CLAREMONT BUSINESS PARK 2 FILING NO. 2

CONSTRUCTION PLANS

JUNE 2023

V2_Construction Drawings.pdf Markup Summary

EX MEADOWBROOK PKY - EL JEFE HTS
 SCALE: 1"=10'

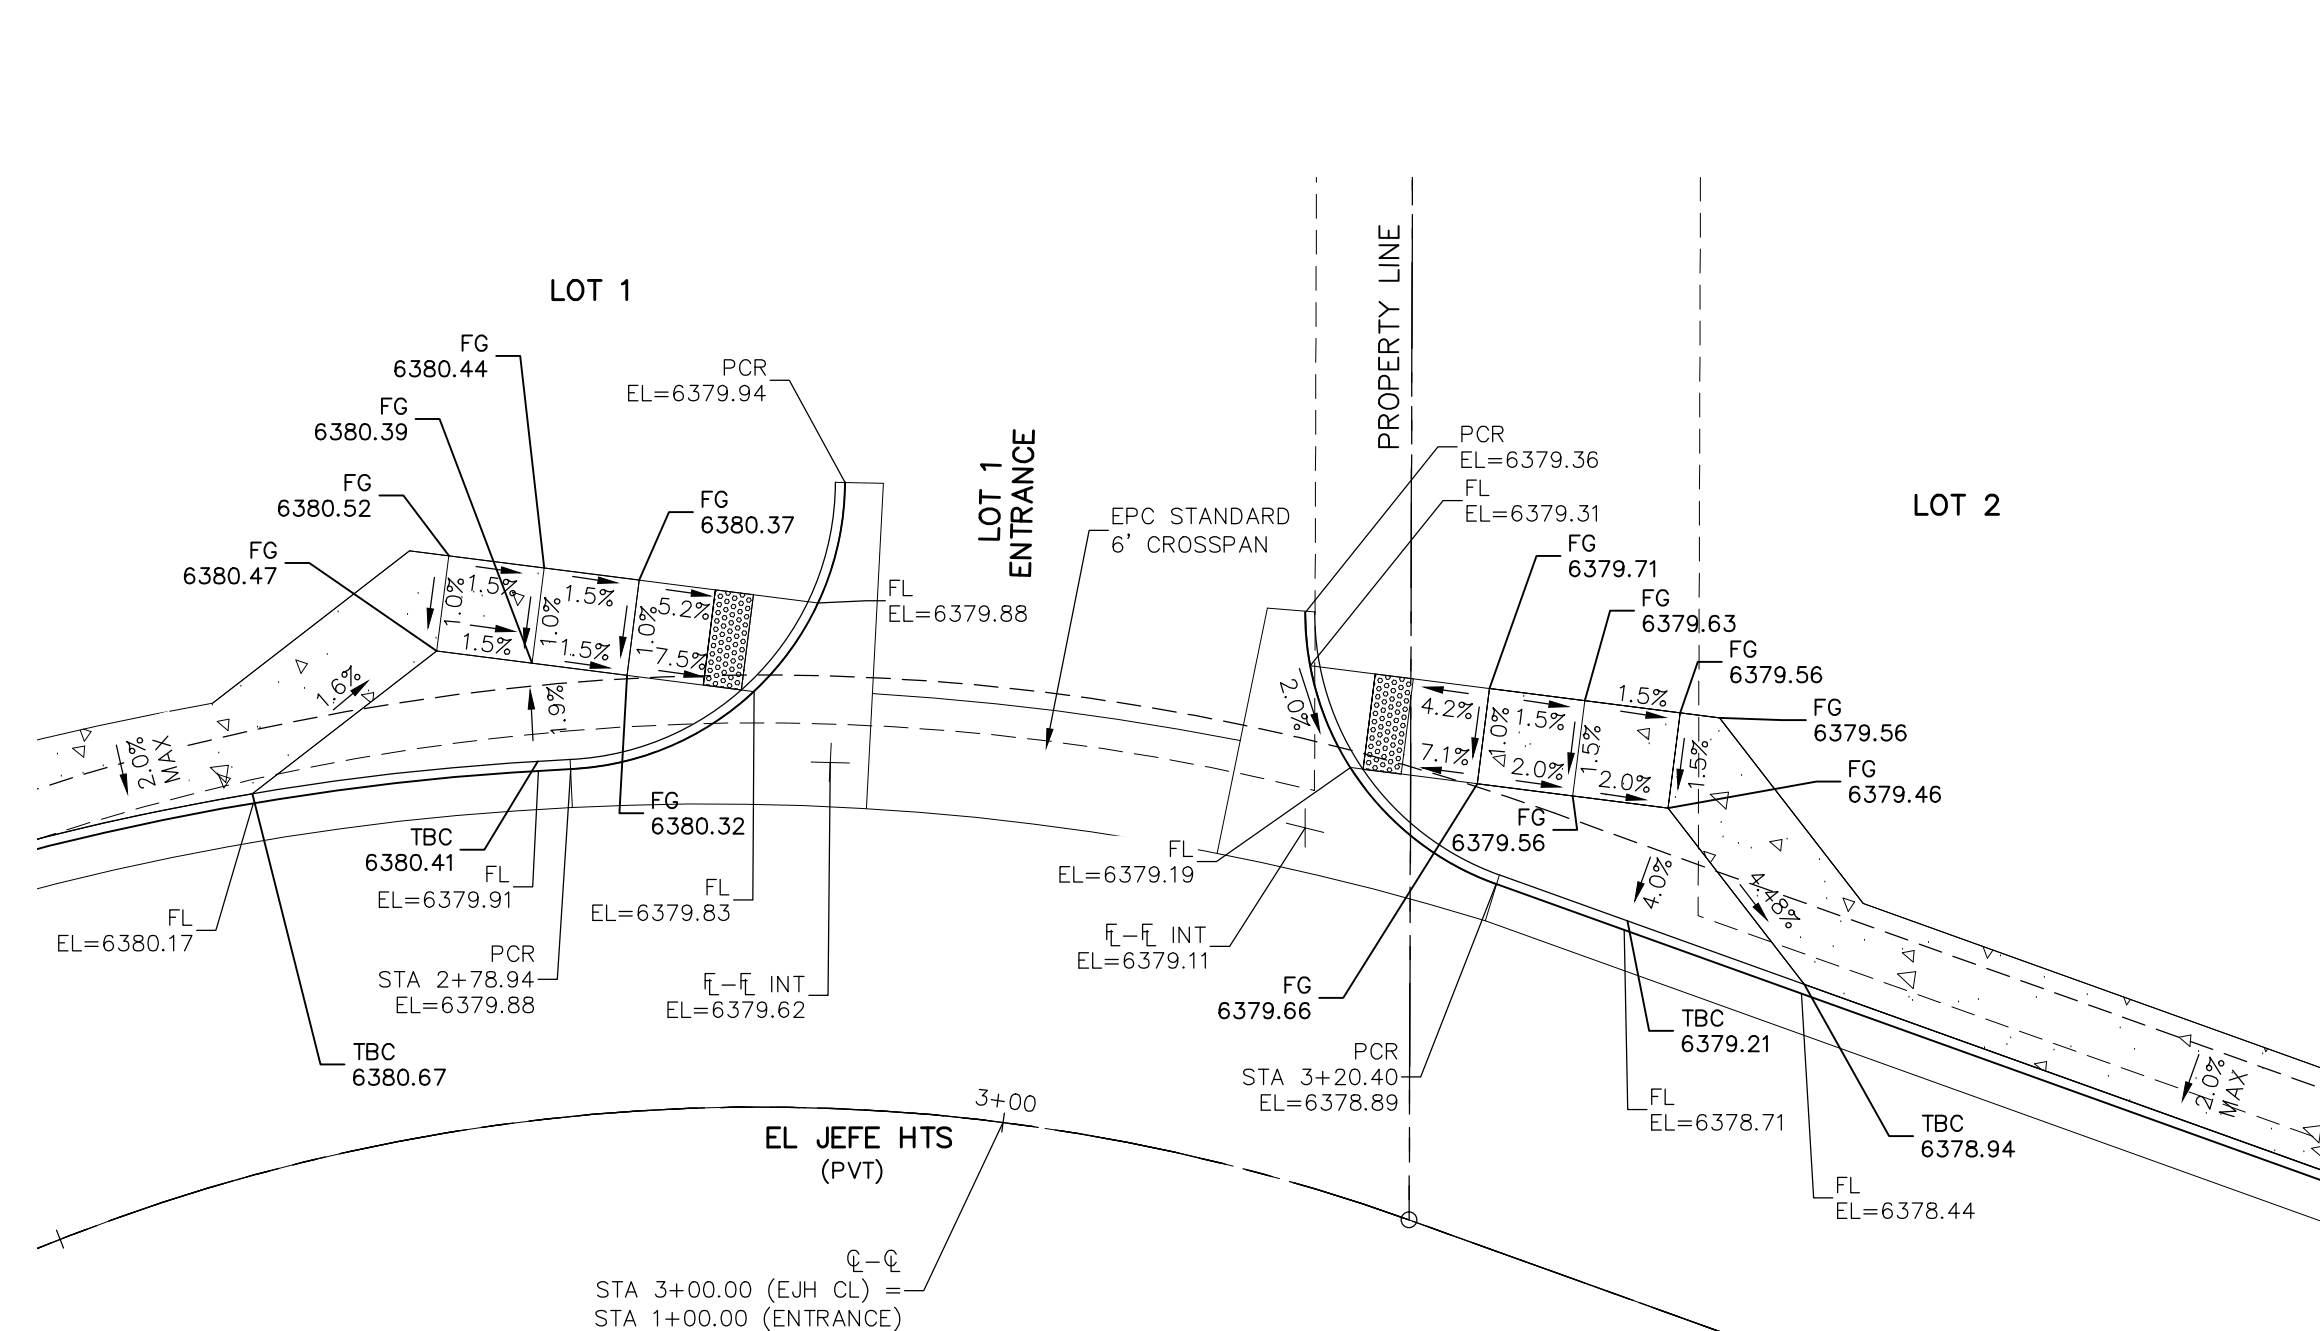
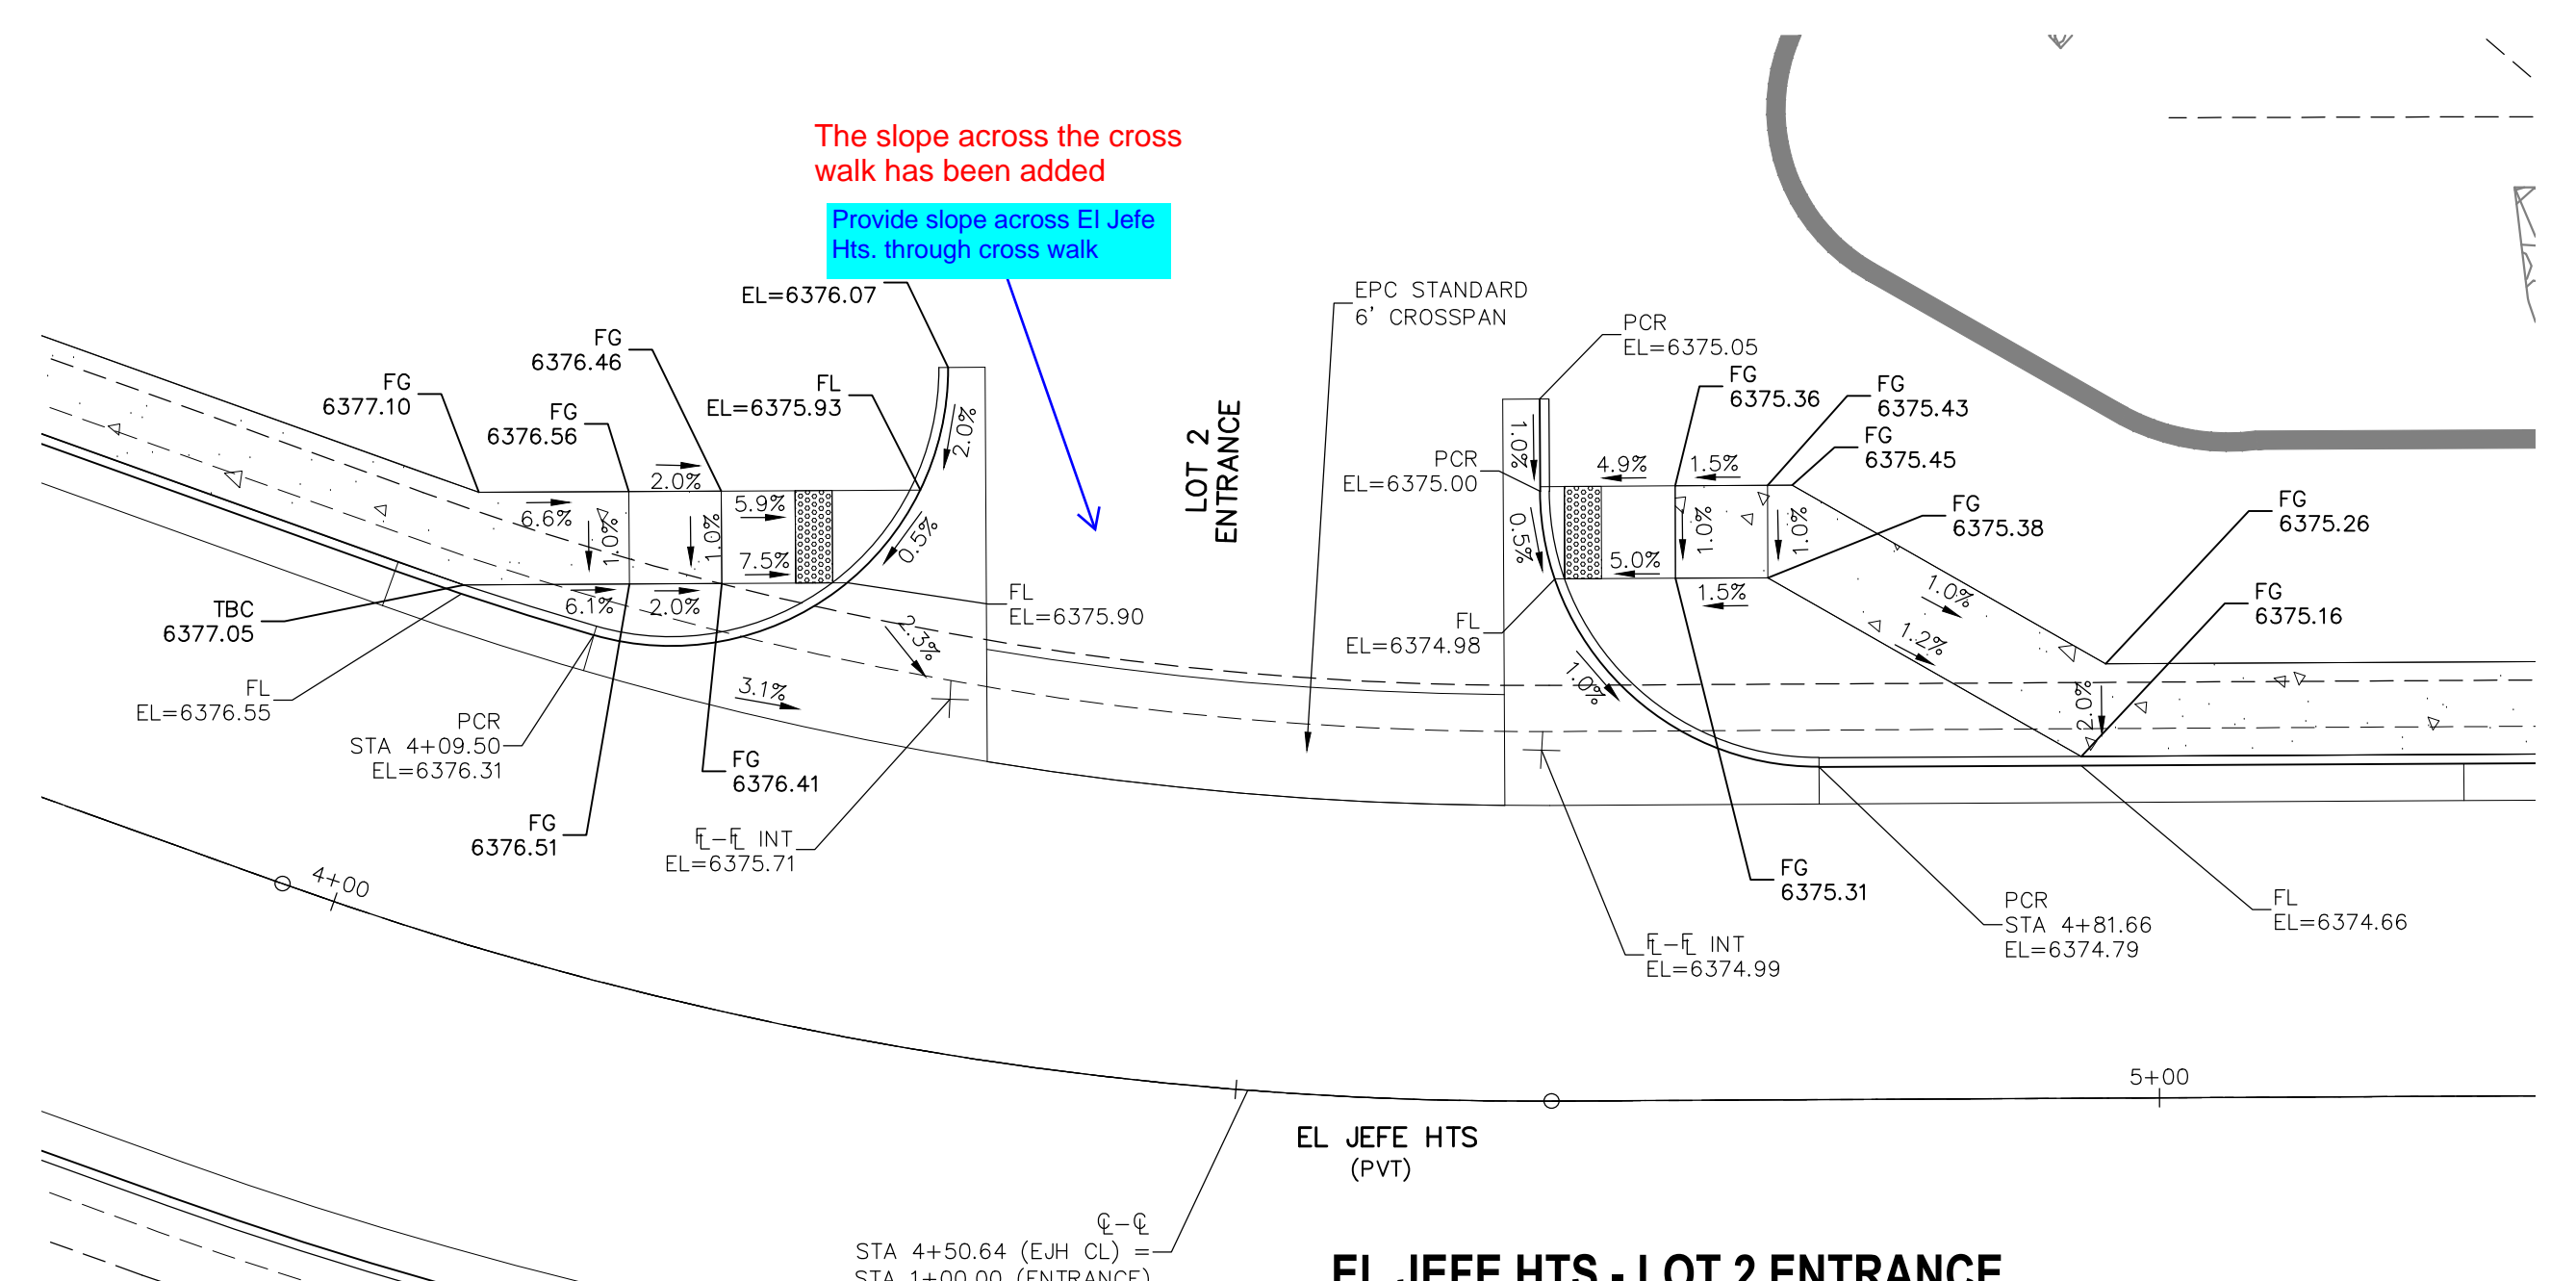
This has been labeled as existing and temporary.
 Label as existing and temporary.
 Label this line or turn off.
 This line is the 7' public utility & drainage easement on the other side of the property line and has now been labeled.

The slope across the cross walk has been added
 Provide slope across El Jefe Hts. through cross walk

**STORM 1 (PRIVATE)
STA 0+10.70 TO STA 5+87.86**

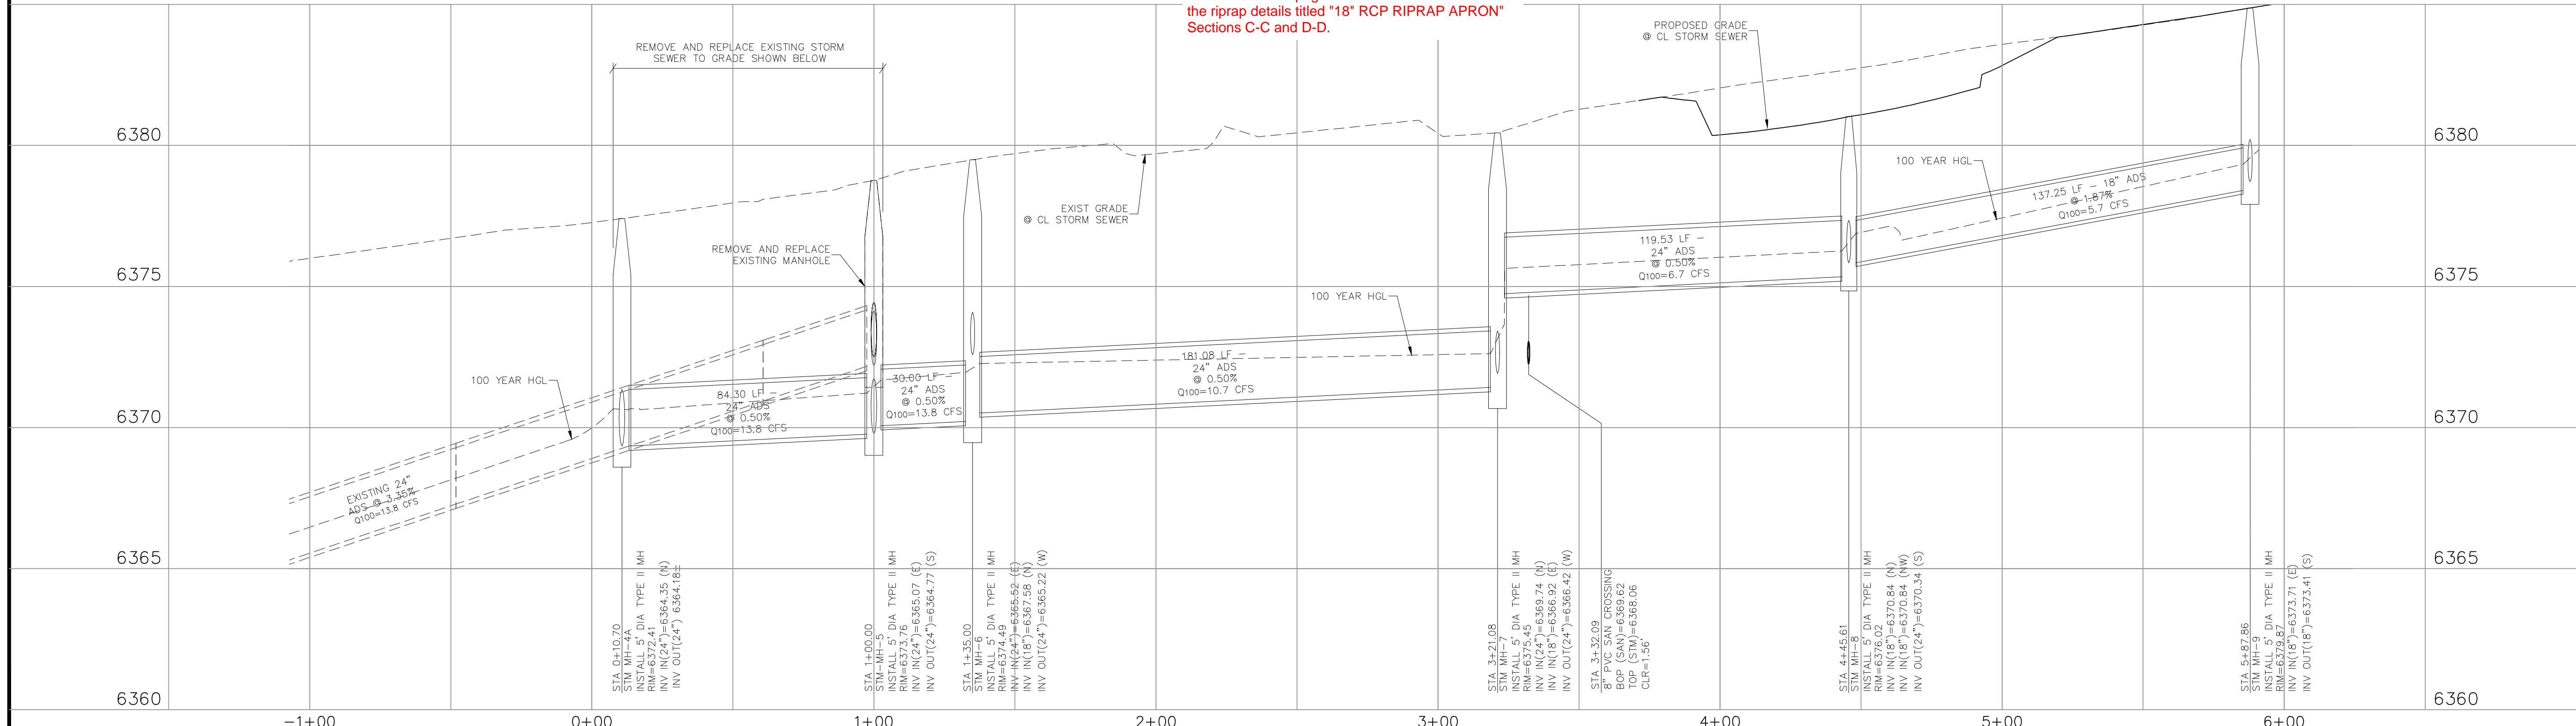
Unresolved: Provide riprap details
 Details are included within the BMPs. Please refer to sheet BMP02 on page 13 of this sheet set and view the riprap details titled "18" RCP RIPRAP APRON" Sections C-C and D-D.
